P 526634

## ON-SITE SEWAGE DISPOSAL SYSTEM HOWARD COUNTY HEALTH DEPARTMENT BUREAU OF ENVIRONMENTAL HEALTH

SUBDIVISION: Homewood Crossing LOT NUMBER: 4

ADDRESS: 11413 Hunt Crossing Court PROPERTY OWNER: Toll MD III LP

A 515042-D

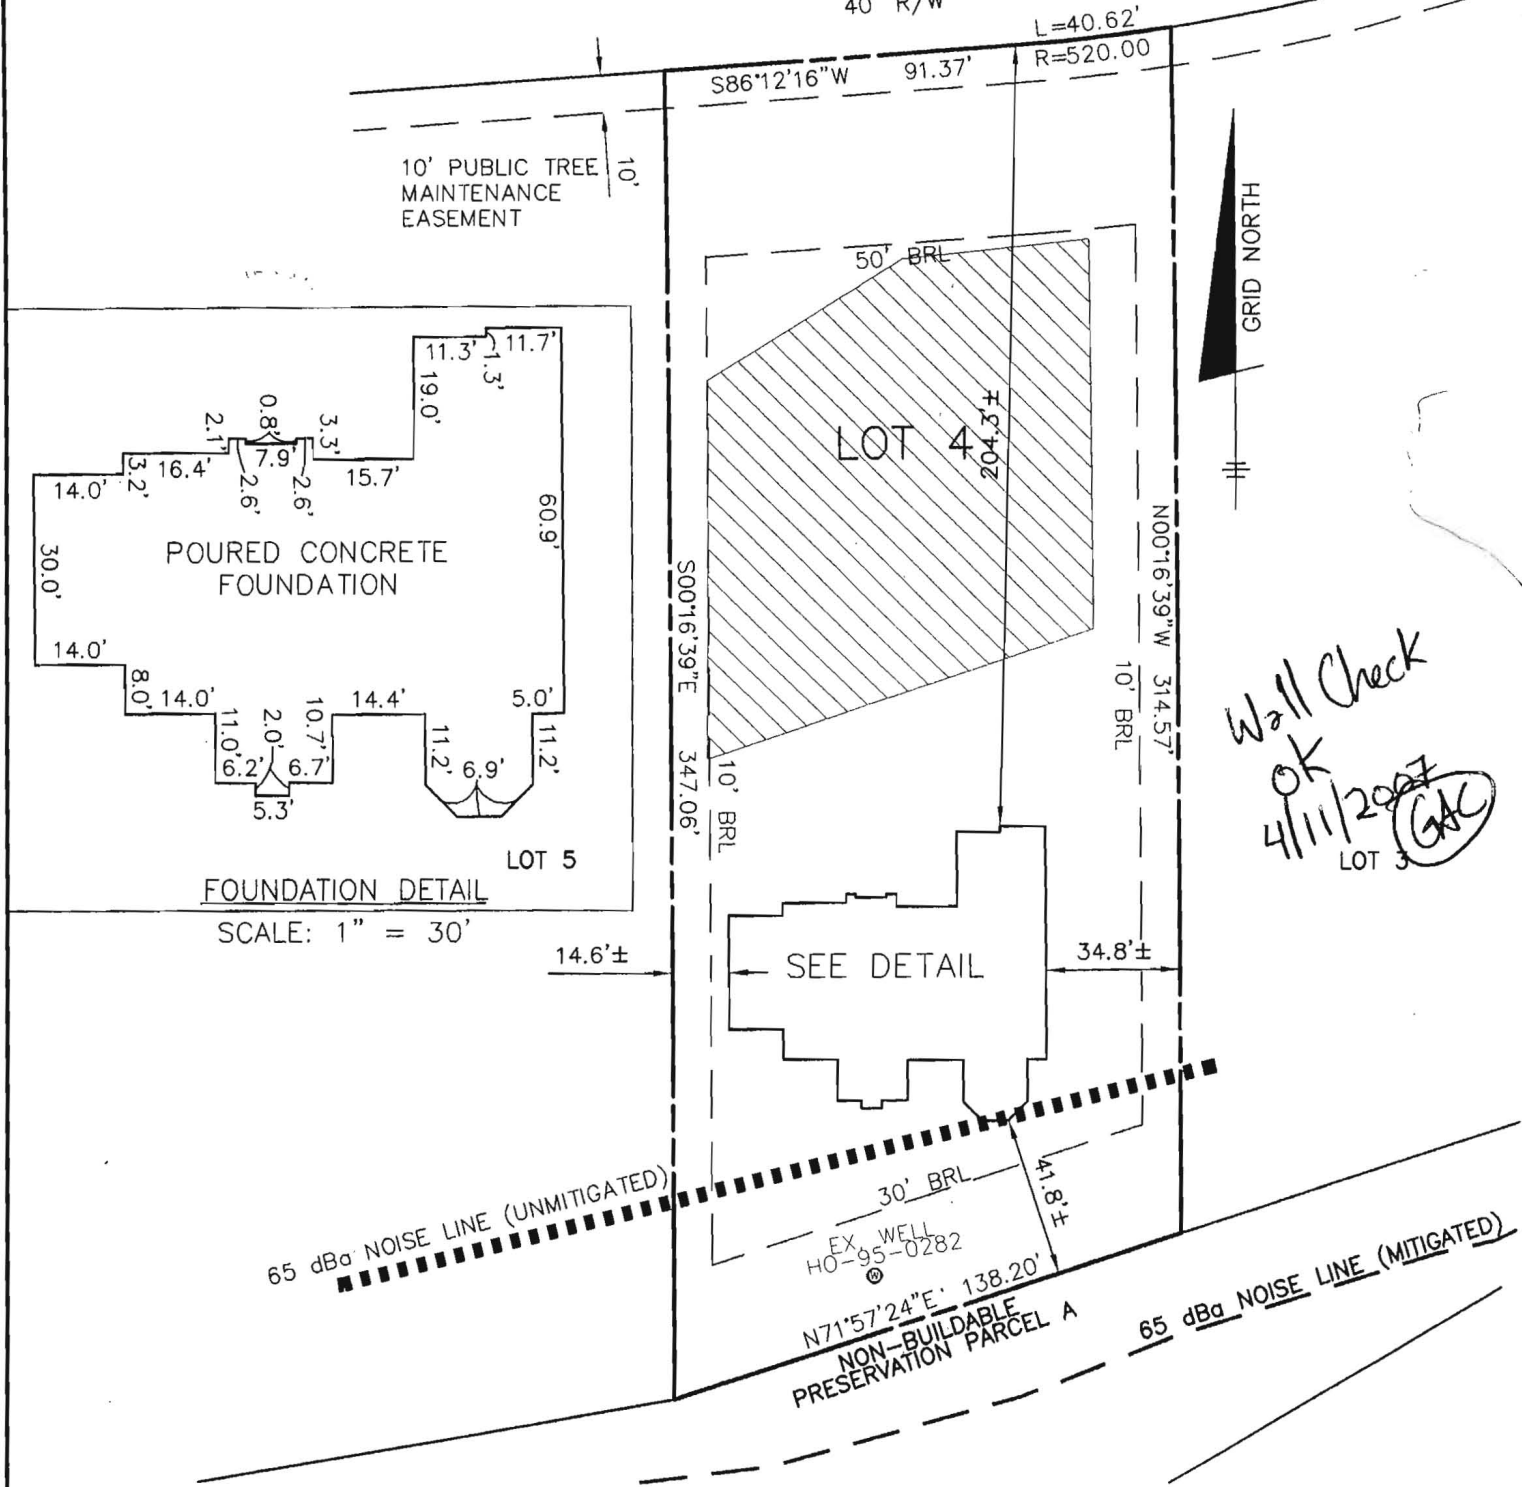
PRE-CONSTRUCTION 4/12/07 Install Tank per plan. Run 4x50' trenches on contour All to one side of easement. (KW)

INSTALLATION 4/17/07 Tanks set per plan. No plumbing from house to tank. D box set, Top trench dug and stoned. (KW)

4/17/07 All trenches completed. Need plumbing house to D box. (KW) 4/23/07 Got measurements for house connection, Everything else covered. (BB)
